Dewsbury RFI issued: 4/09/24

Due: 18/09/2024

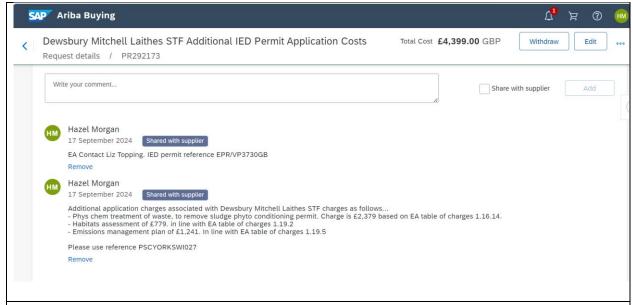
• £2,379 (1.16.14) - Physical Chemical treatment of waste - Minor variation to remove existing Phyto conditioning activities but not the land

This payment has been raised with reference PSCYORKSWI027. Please see screen shot below for total additional fee of £4,399. This is currently going through the YW approvals process.
